**RE:** NHESS 2017 376 Schwindt et al.: *Experimental study of sediments traps permeable for frequent floods*

### *Authors response*

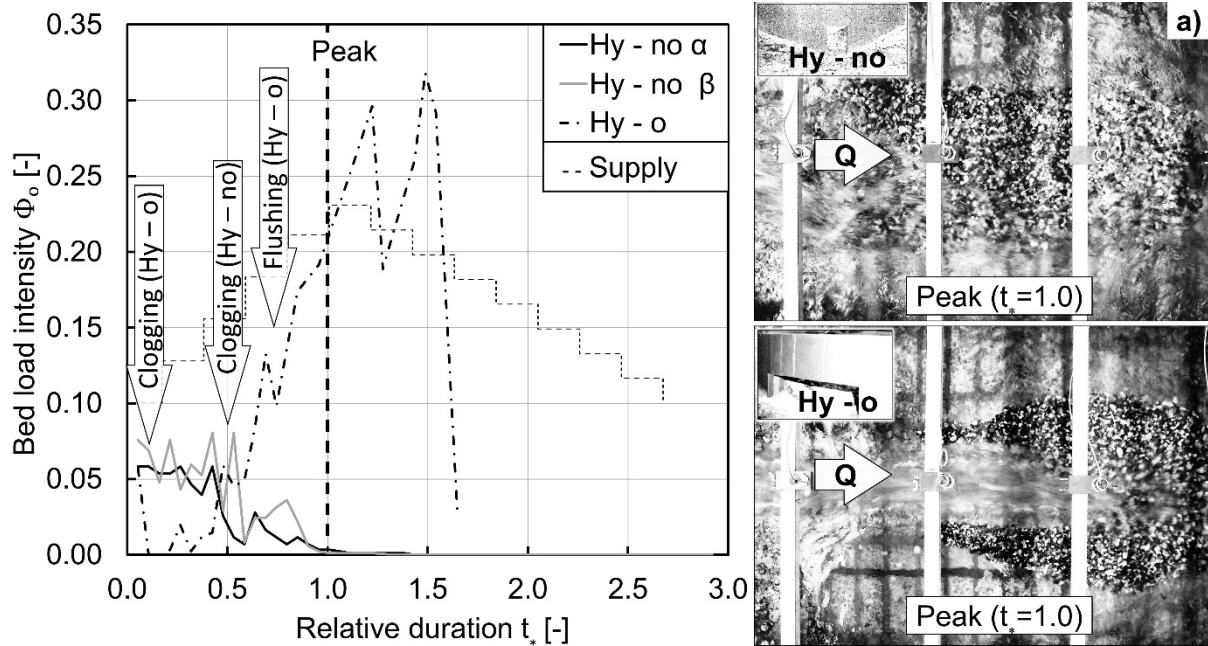
About Figure 8, could be it possible to add the inflowing sediment rate  $\Phi_i$ ?

*We considered adding the sediment supply rate but the graphs became very messy and hard to read – here an example of Fig. 8a, where the graph density is still much lower than in Fig. 8c:*

*In particular, the range, where the bed load outflow and inflow rates are present, is very hard to interpret. This is why we opted to present the sediment supply rate apart from Fig. 8, with the hydrograph in Fig. 7.*
